ADDENDUM NO. 5

DATE: March 18, 2020

PROJECT: Hammond High School Renovation and Addition
Columbia, Maryland
Architect Project No. 18011

1 P4.02 FIRST FLOOR PLAN - AREA B - PLUMBING
SCALE: 1/8" = 1'-0"

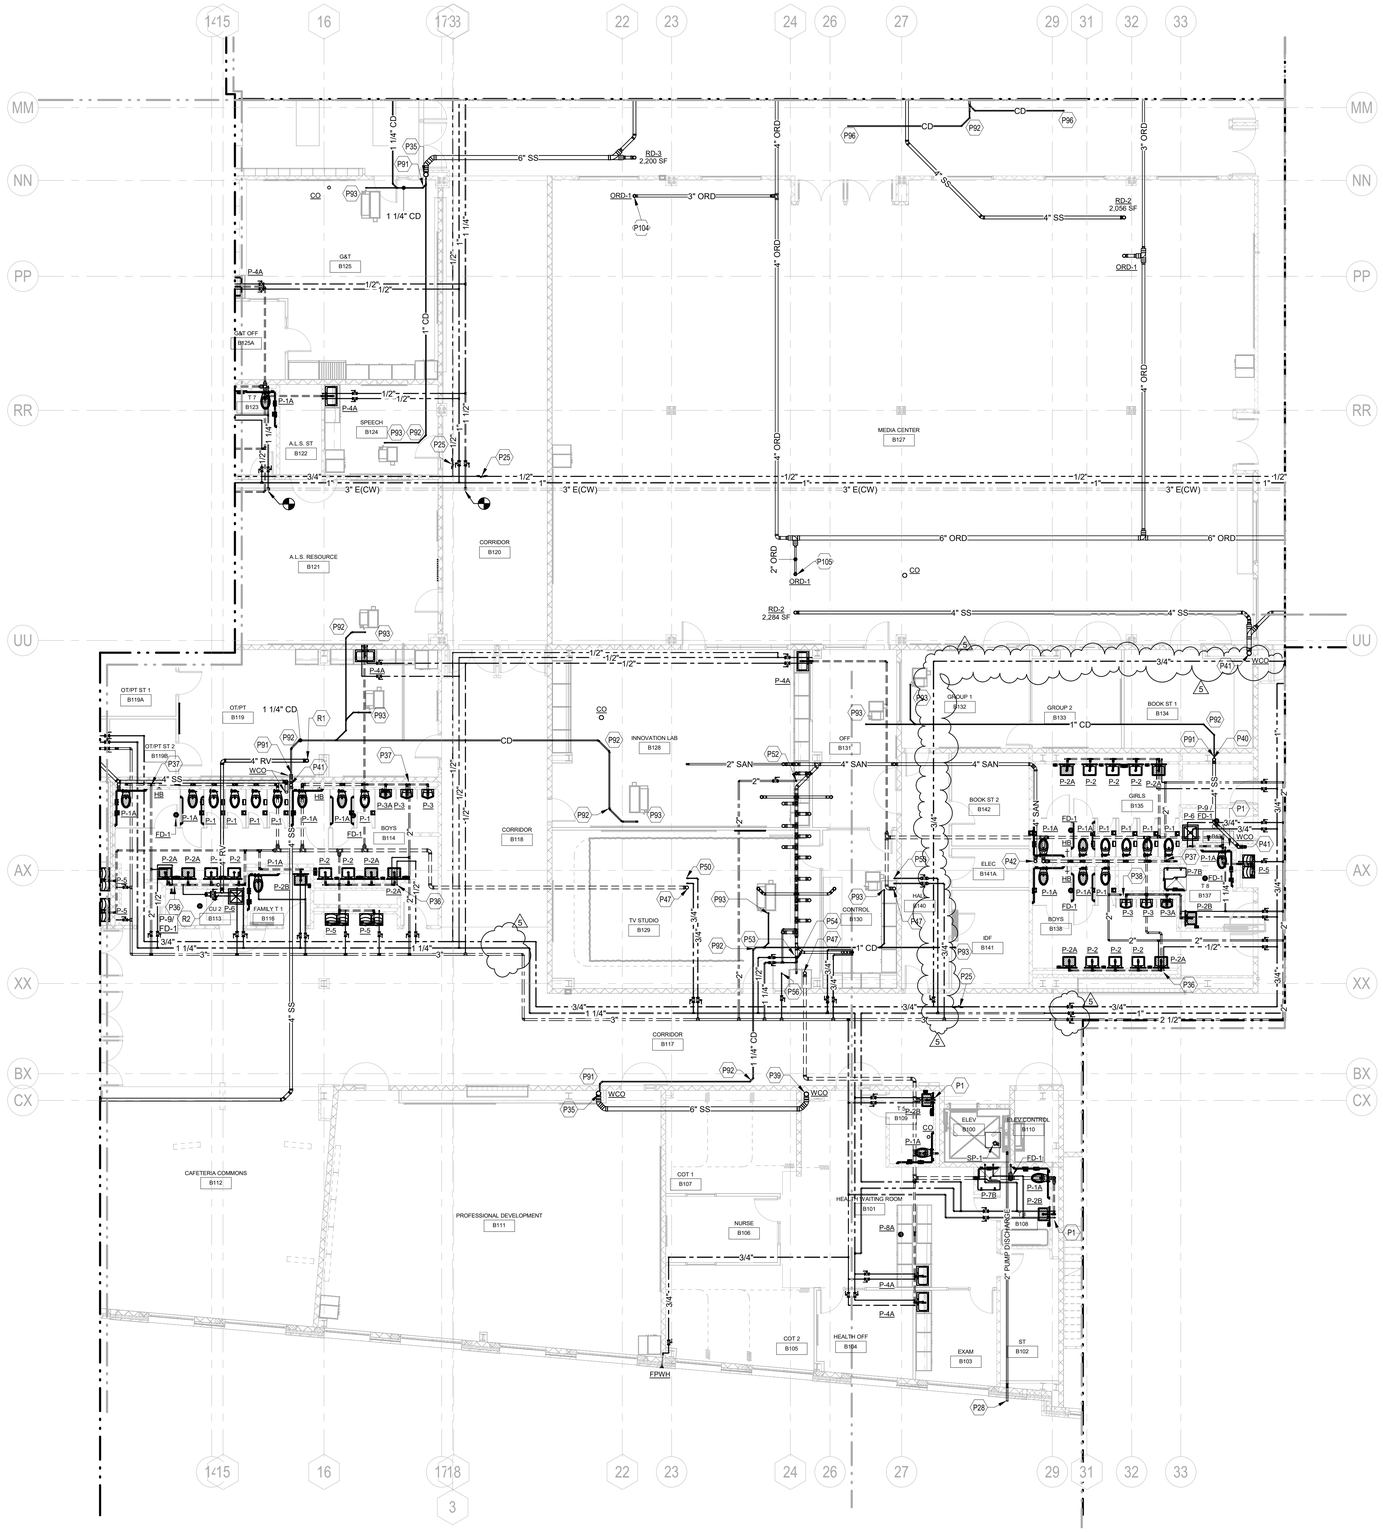
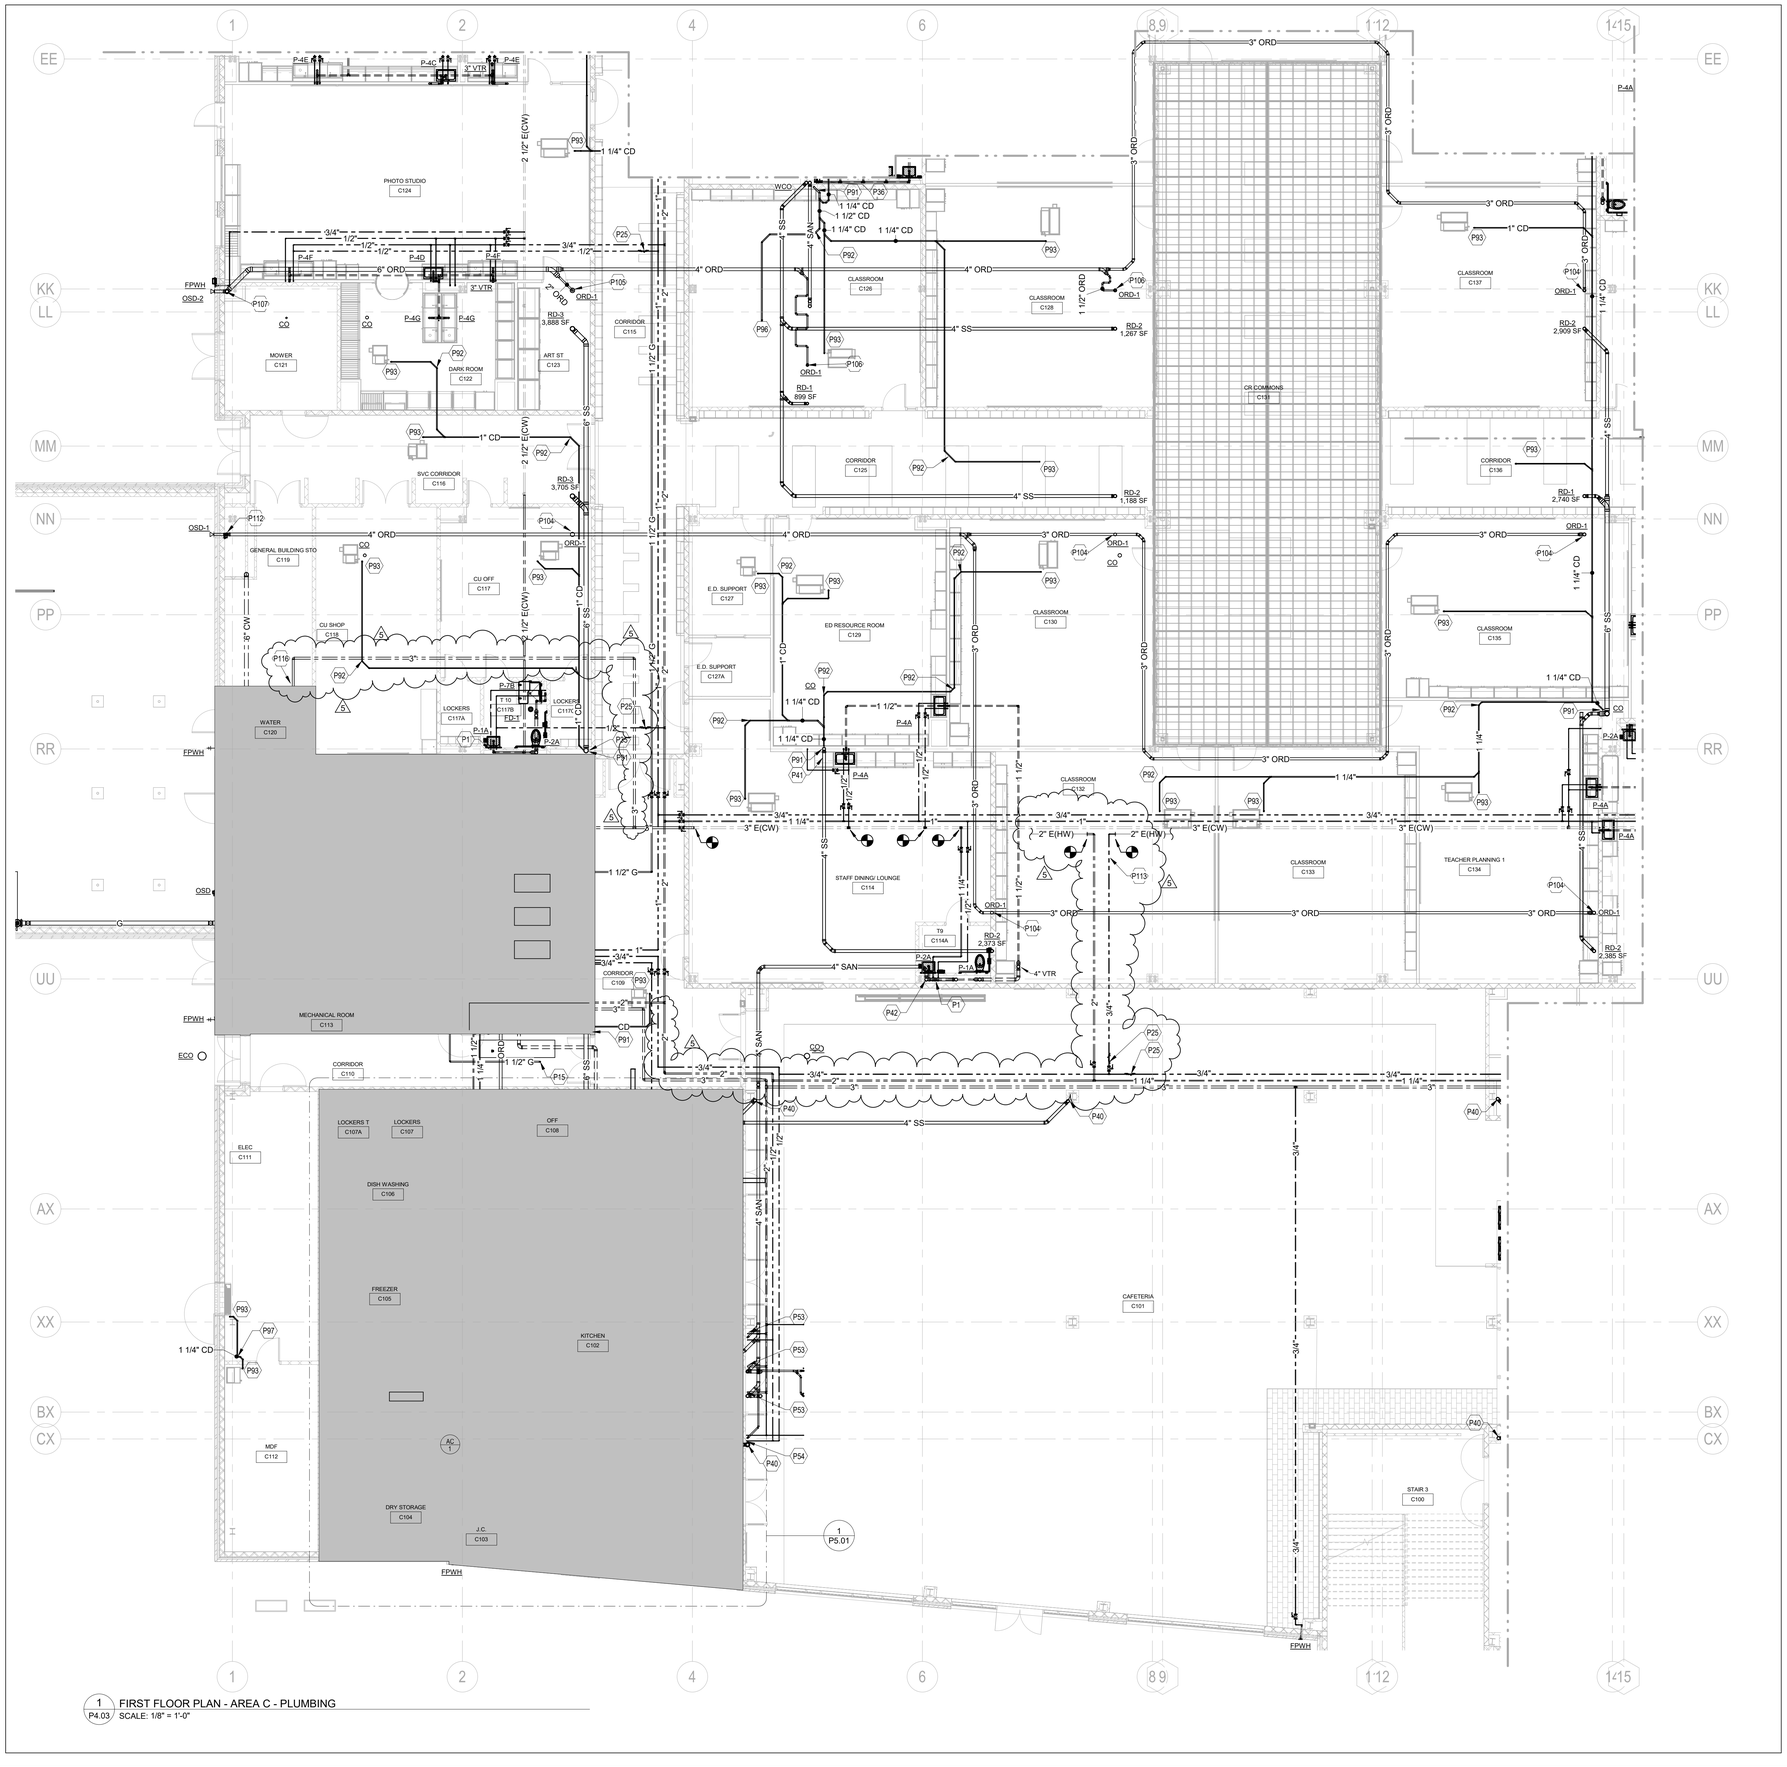
- ❑ Sheet P4.02 – FIRST FLOOR PLAN – AREA B – PLUMBING
  - **REPLACE SHEET** P4.02. **ADD** Hot water supply and return piping for phasing issues.
- ❑ Sheet P4.03 – FIRST FLOOR PLAN – AREA C – PLUMBING
  - **REPLACE SHEET** P4.03. **ADD** Hot water supply and return piping for phasing issues.
- ❑ Sheet P4.07 – FIRST FLOOR PLAN – AREA G – PLUMBING
  - **REPLACE SHEET** P4.07. **ADD** Hot water supply and return piping for phasing issues.
- ❑ Sheet P4.08 – FIRST FLOOR PLAN – AREA H – PLUMBING

2 SECOND FLOOR PLAN - LIGHTING - AREA B & C
E2.11 SCALE: 3/32" = 1'-0"

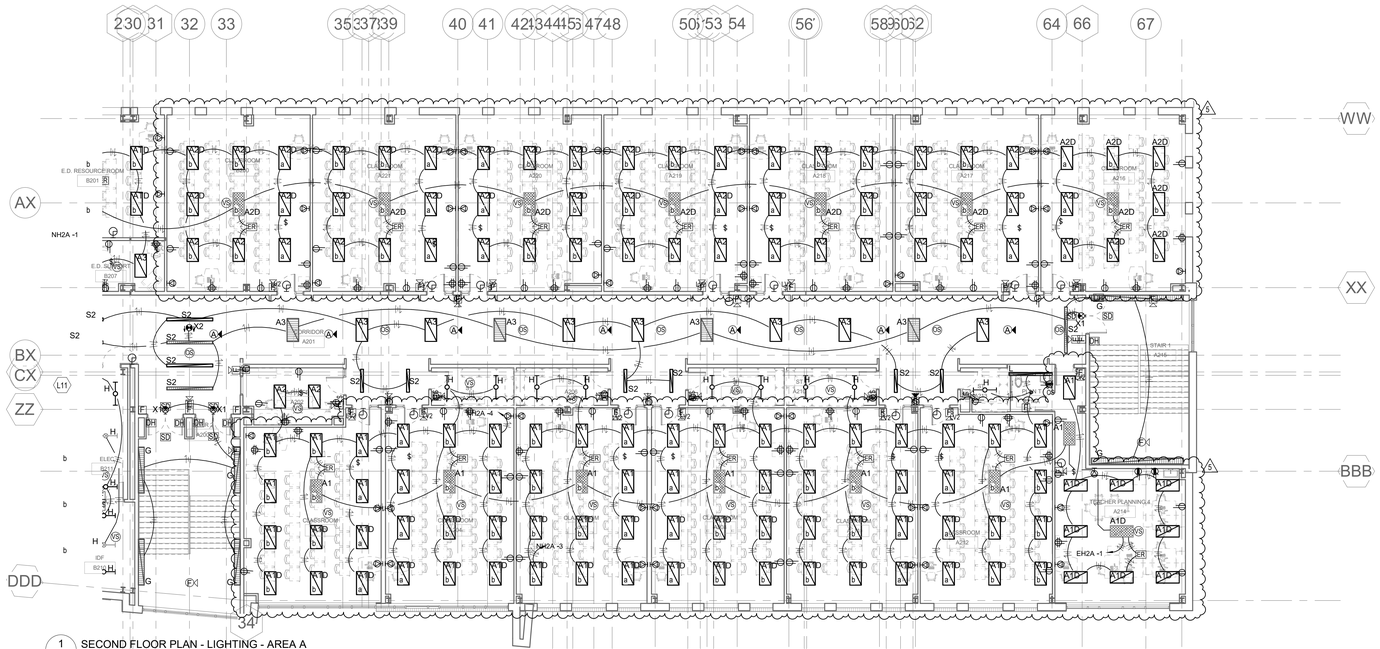
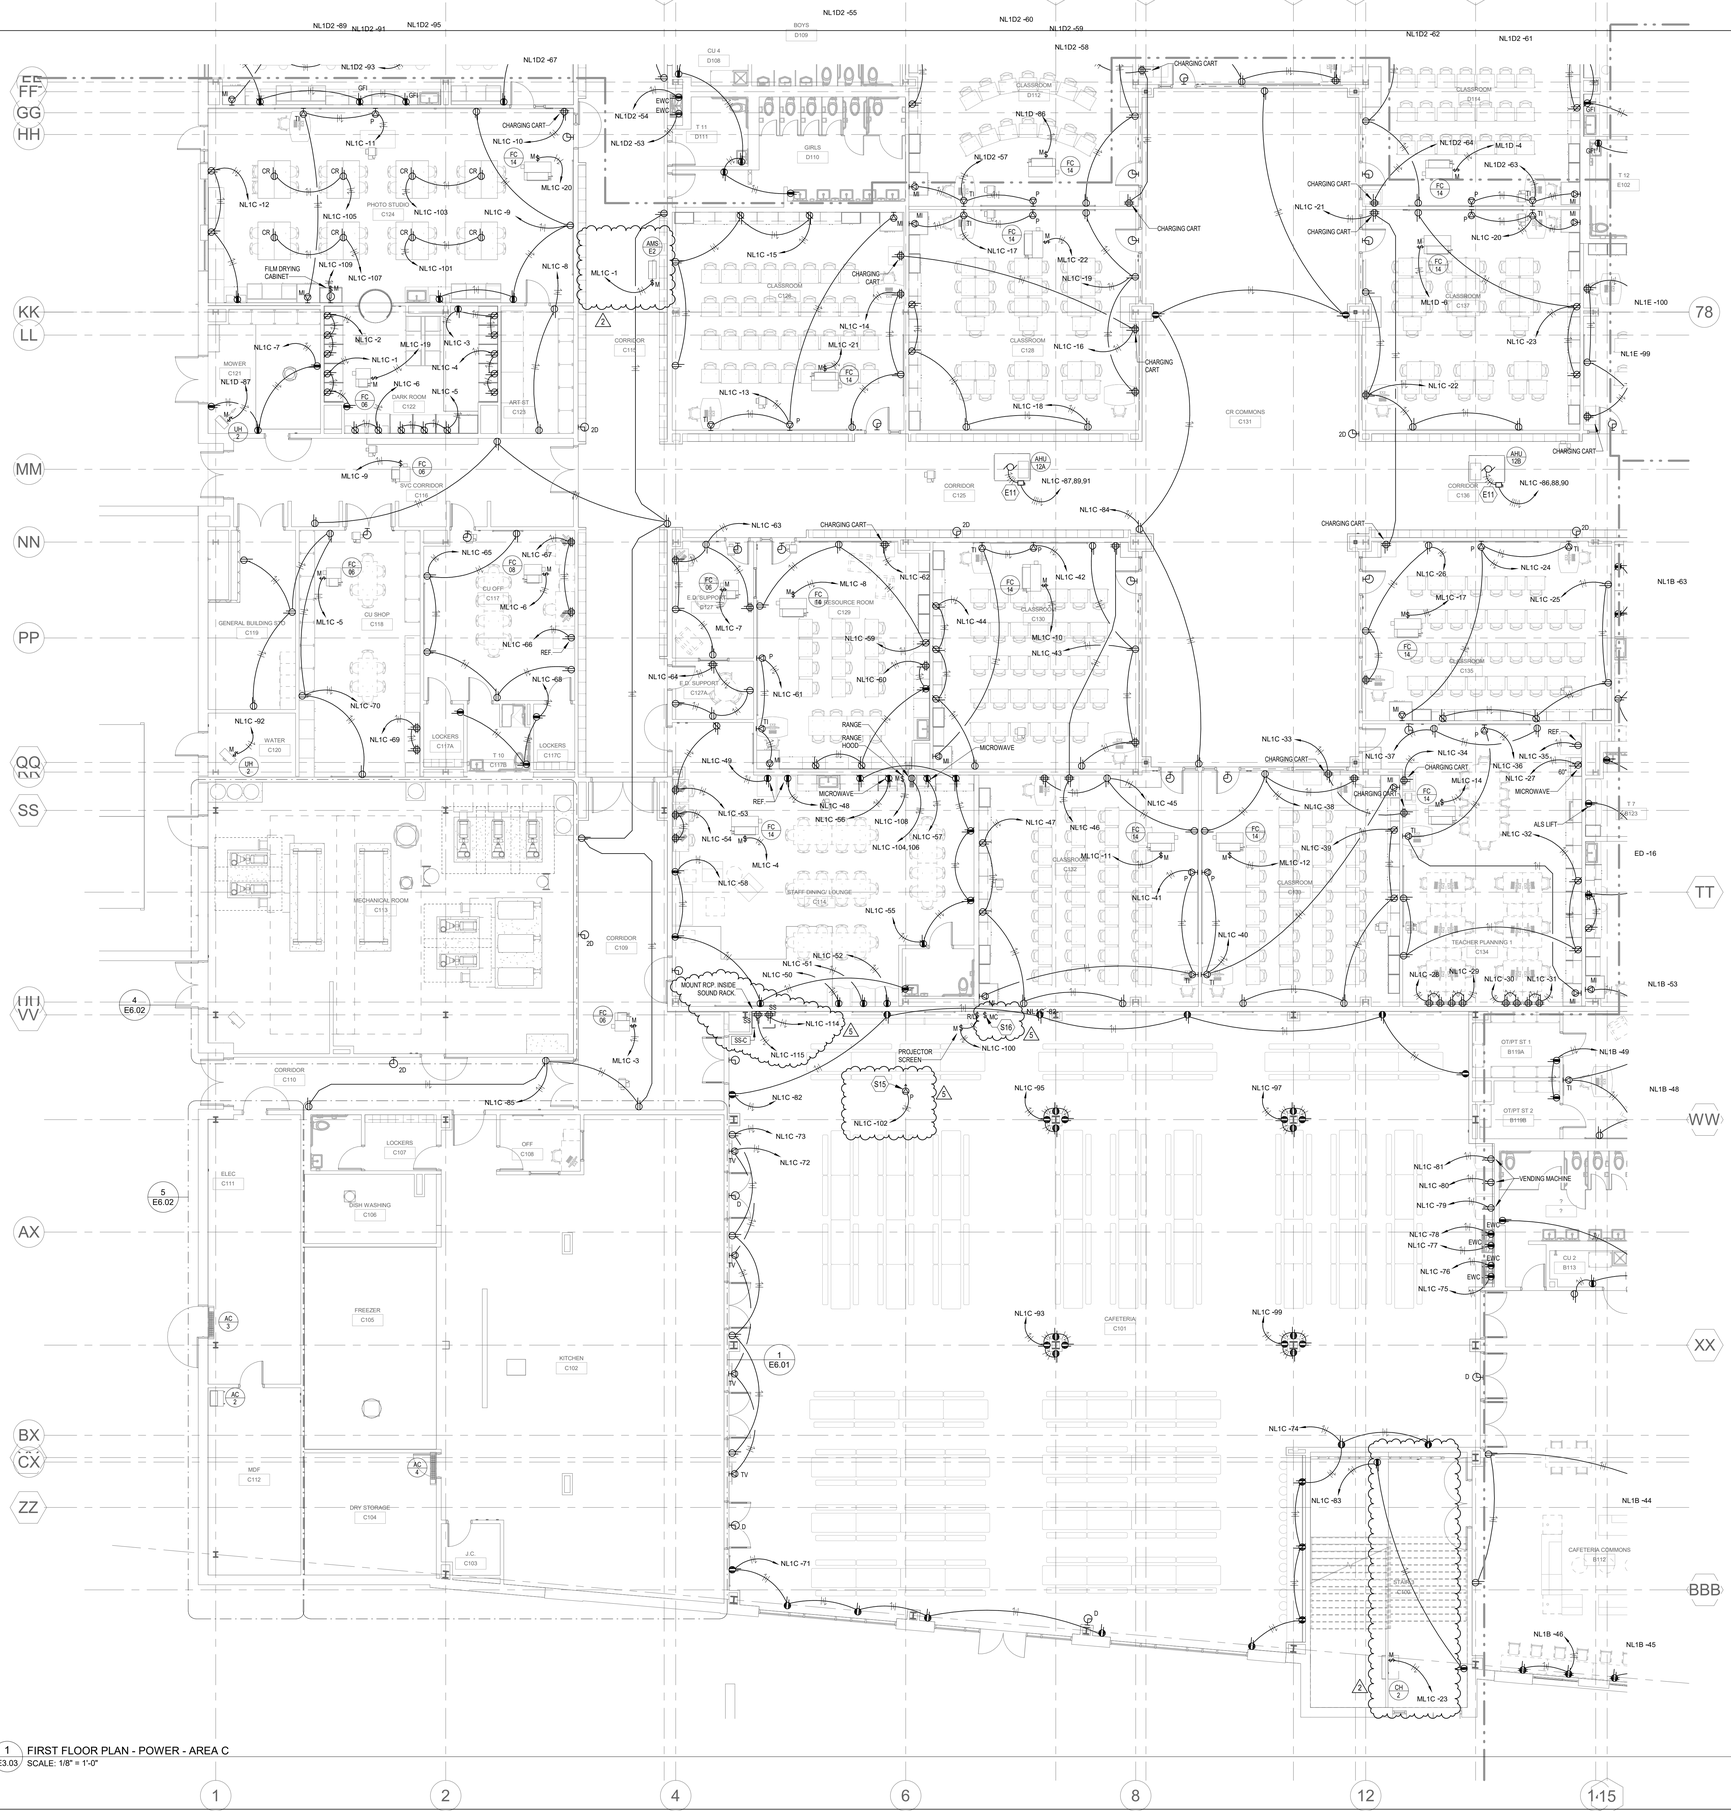
- Sheet E2.11 – Second Floor Plan – Area A, B and C – Lighting
  - **REPLACE SHEET** – Lighting Changes, see revision clouds.
- Sheet E3.03 – First Floor Plan – Area C – Power

1 E3.03 FIRST FLOOR PLAN - POWER - AREA C
SCALE: 1/8" = 1'-0"

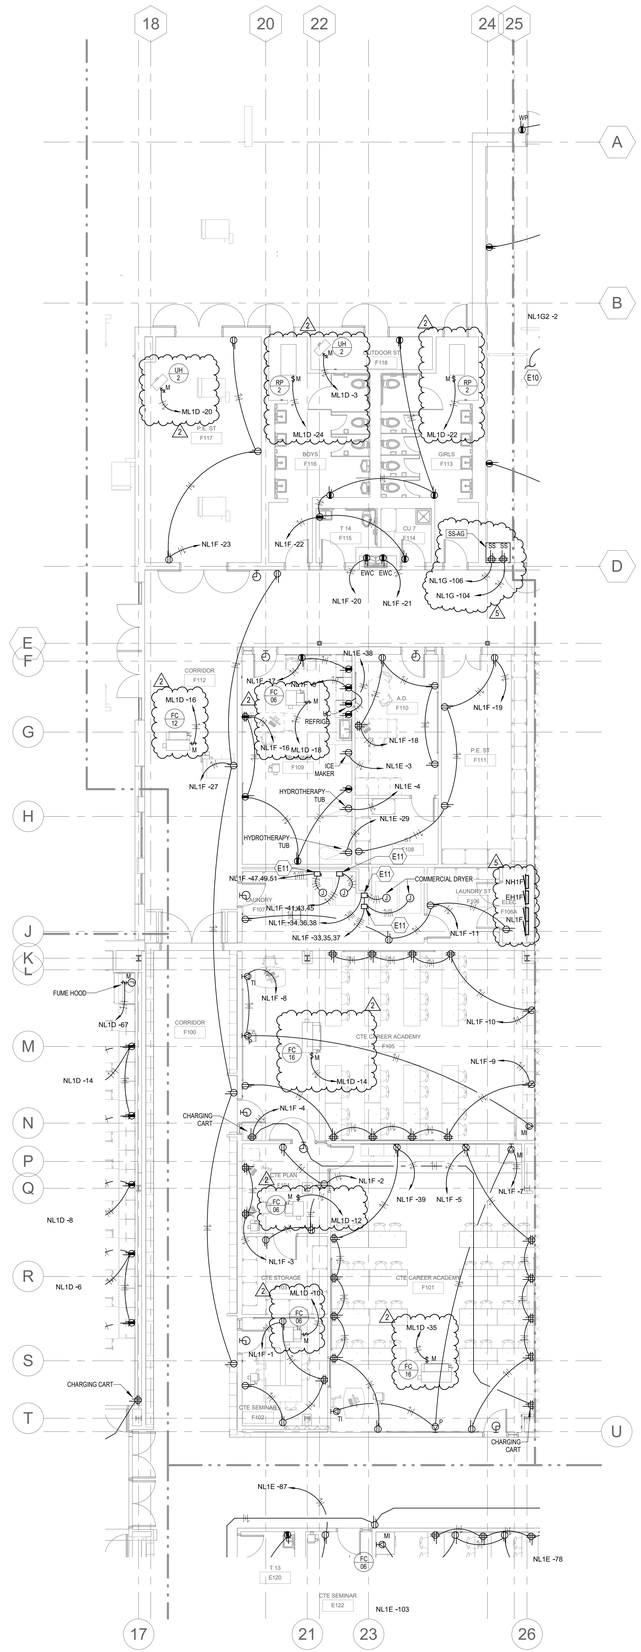
- **REPLACE SHEET** – AV changes, see revision clouds.
- Sheet E3.05 – First Floor Plan – Area E and F – Power
  - **REPLACE SHEET**
    - **ADD** – Aux Gym G112 Sound rack shall be located in plan south west corner. Provide two (2) dedicated surge suppression quadruplexes for sound rack. Route three (3) #10 conductors in 3/4" conduit to 20A/1P breaker in panelboard "NL1G".
